**ADDENDUM NO. ONE**

January 9, 2017

**Sanctuary & Classroom Addition  
THE CARPENTER'S CHRISTIAN CHURCH  
Harrodsburg, Kentucky**

Re: Addendum No.1  
The Carpenter's Christian Church  
Harrodsburg, KY  
BK Project No: 16069.01

DATE: 10-31-2016  
PROJECT: 1010  
REV: 1-3-HWDWUDMS

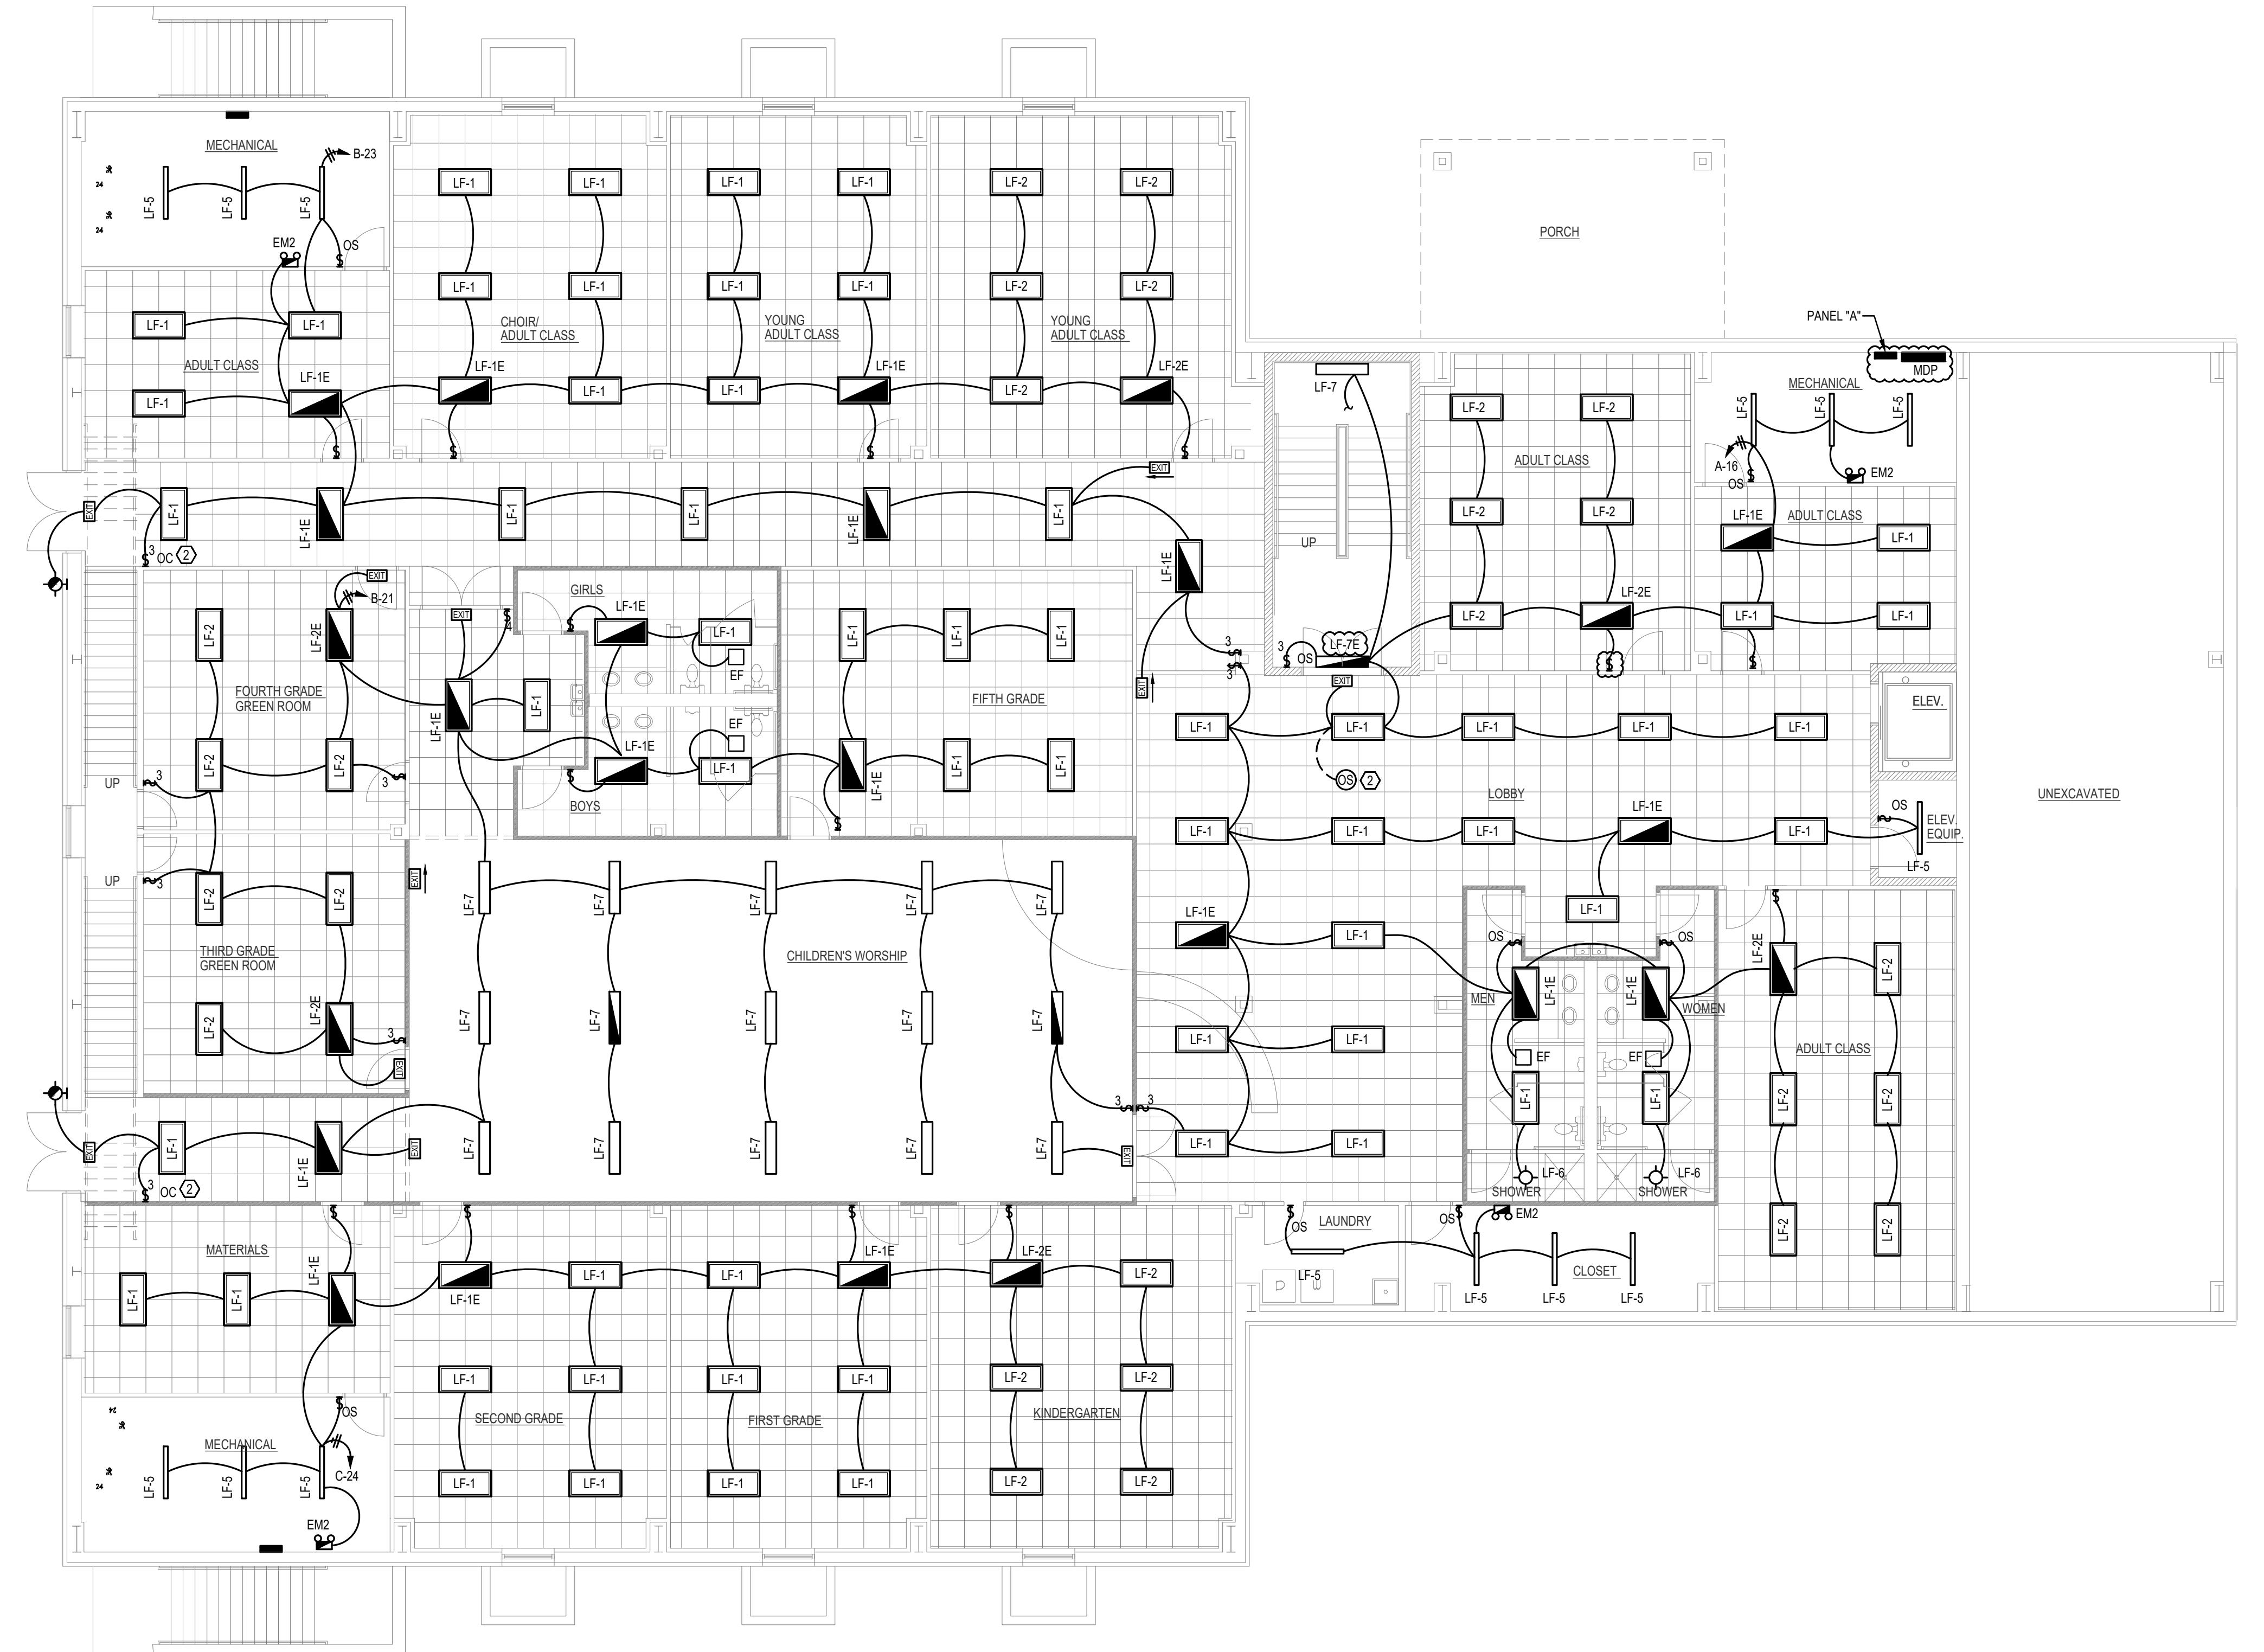
18. Regarding painting of the exposed structure: Paint any exposed structure on drawing A-2, in the Worship Area and Foyer to match the "Simple-Saver" type insulation. On drawing A-1, Paint black exposed structure and wall areas, from the bottom of the beam flanges up to the underside of the floor deck in the "Children's Worship Area", such that a straight line from the bottom of the lowest beam flange to the underside of the floor deck above is all black.

E-2

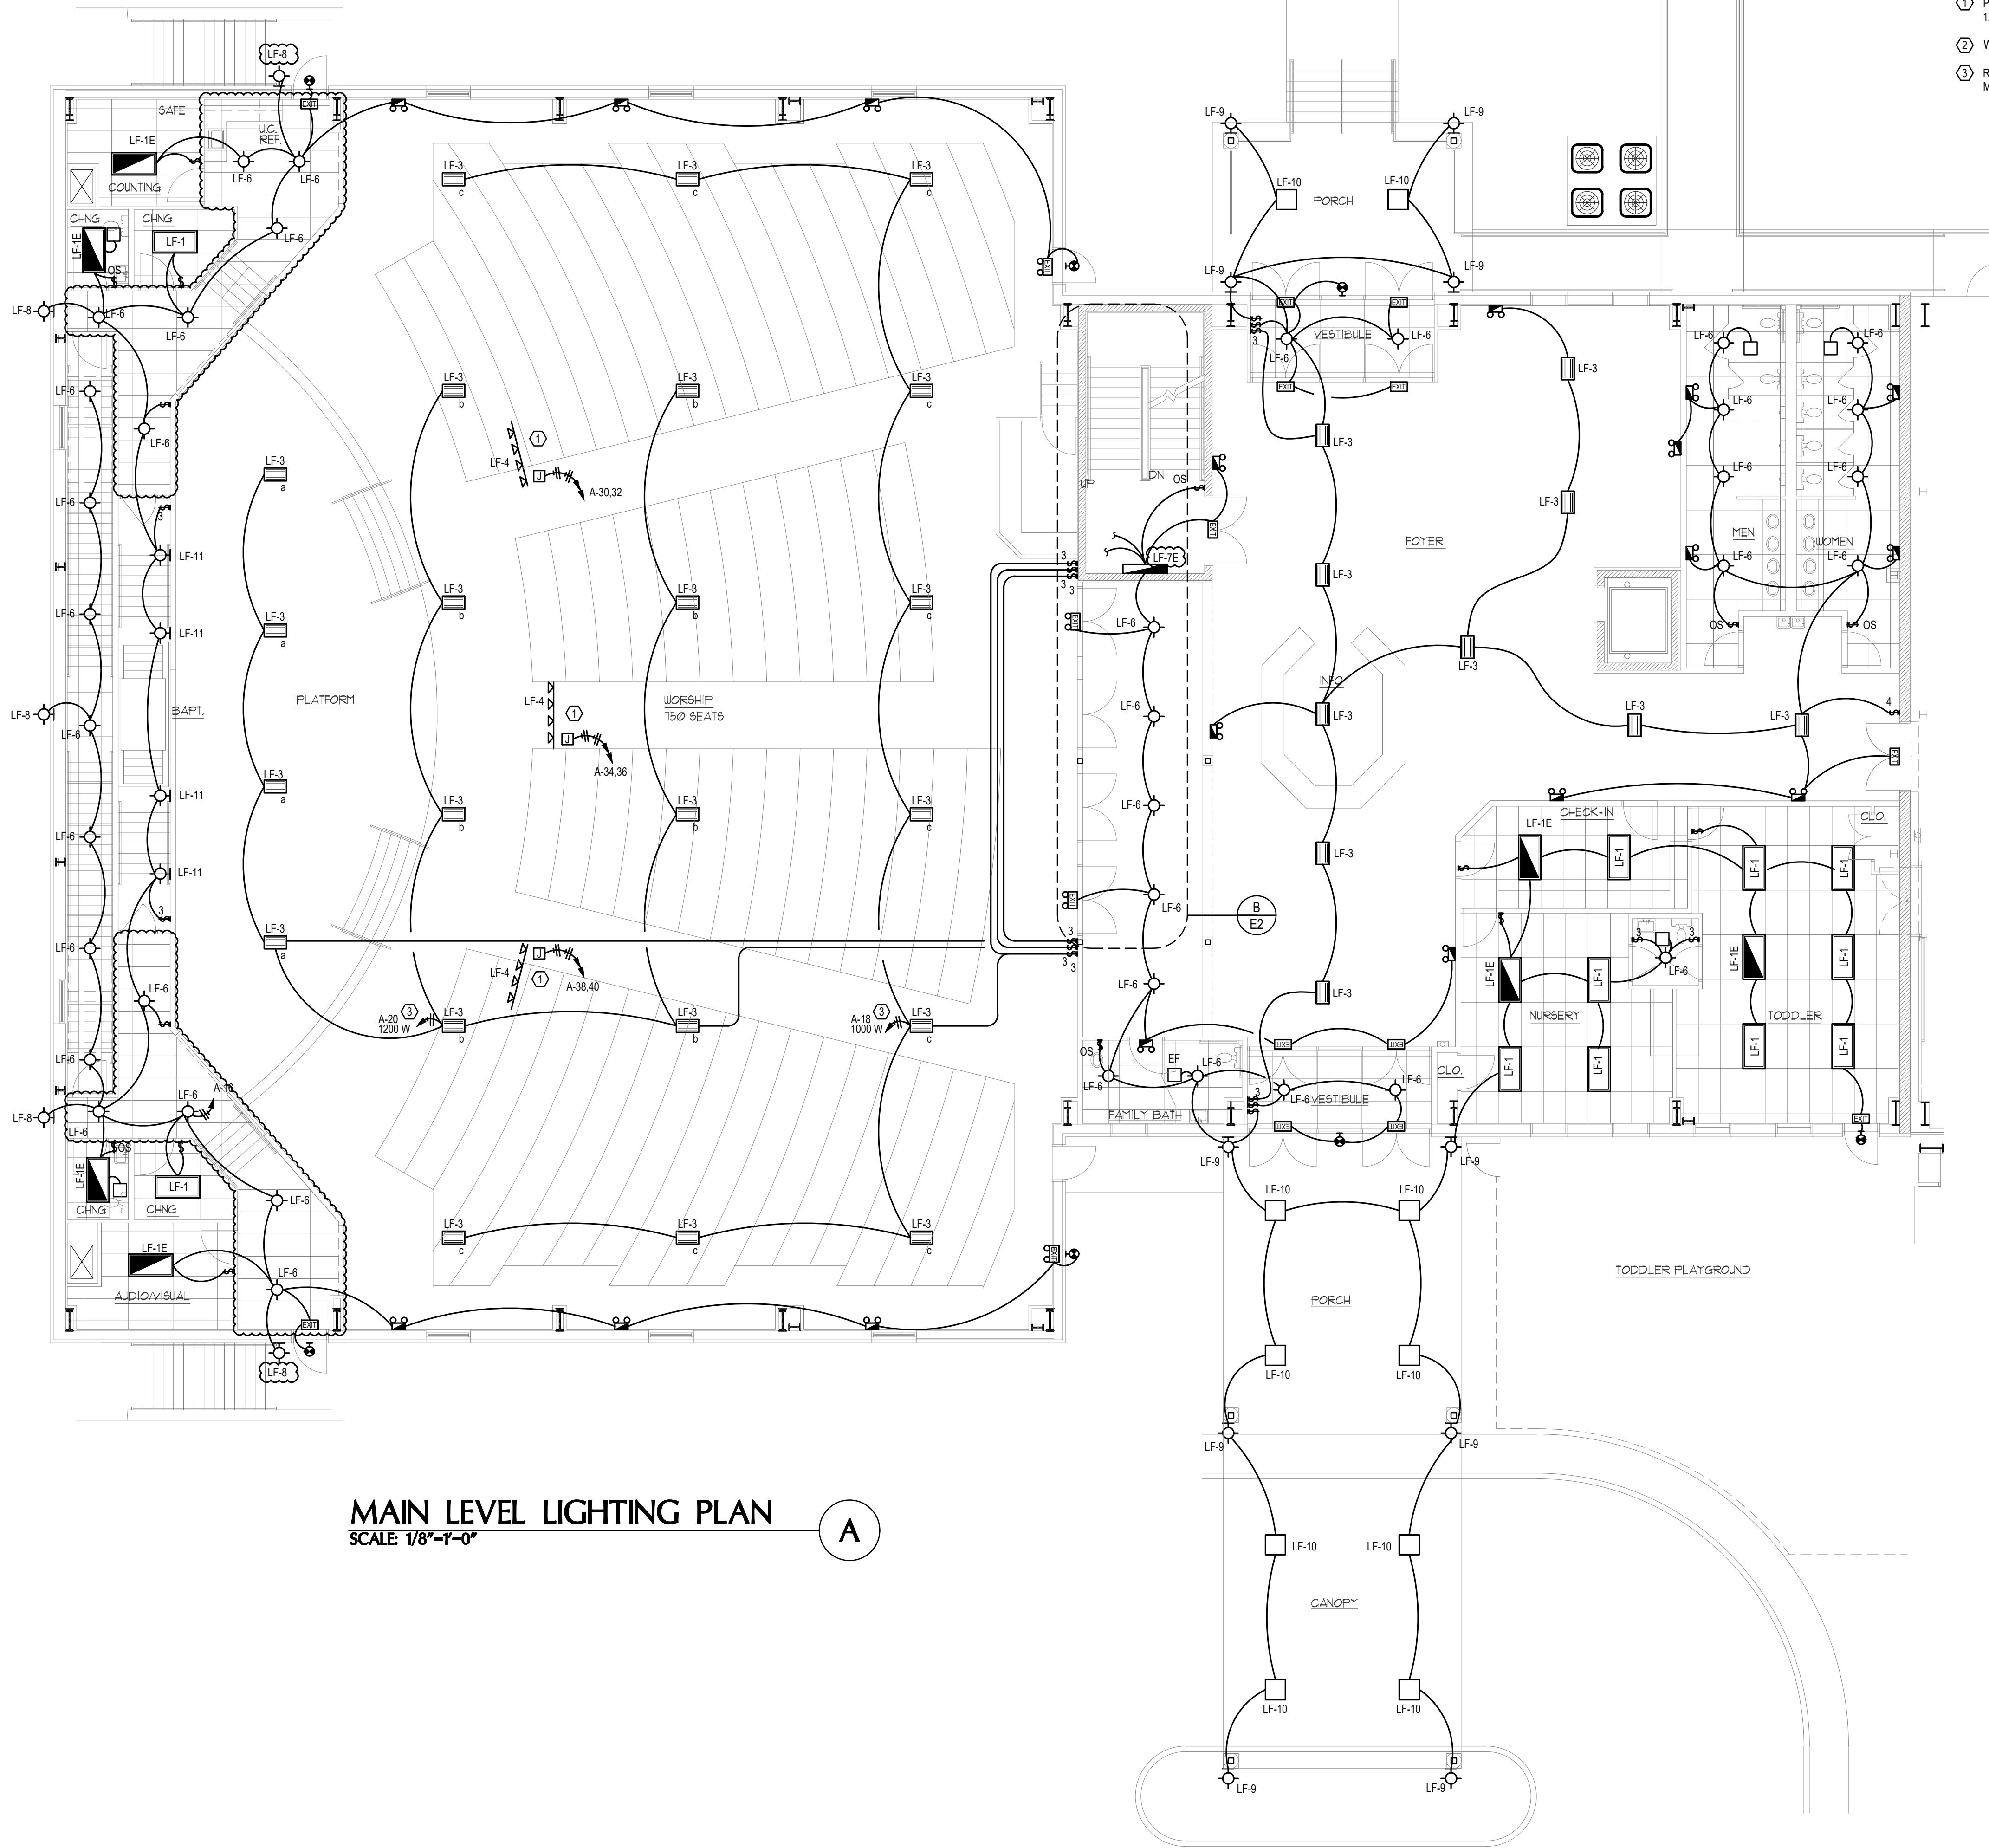
12. Please see attached electrical drawing "E-2" for clarifications of ceiling grid locations in the areas of "Exit 123", "Hallway 124", "Hallway 125", "Exit 126". Note any light fixture changes as a result of adding the suspended acoustical ceilings in these areas on drawing "E-1".

- Light Fixture LF-7 in the main stairwell shall be equipped with emergency batter (LF-7E). At top of stairs and on main level.
- Ceiling below A/V Mezzanine is gyp board, not ceiling tile. Install recessed can lights for mounting to drywall ceiling.
- Change exterior light fixture LF-7 at stage exit doors (top-left and bottom-left of the page) to LF-8 (exterior Wall Pack)
- Light fixtures in back of stage shall be mounted in ceiling grid.
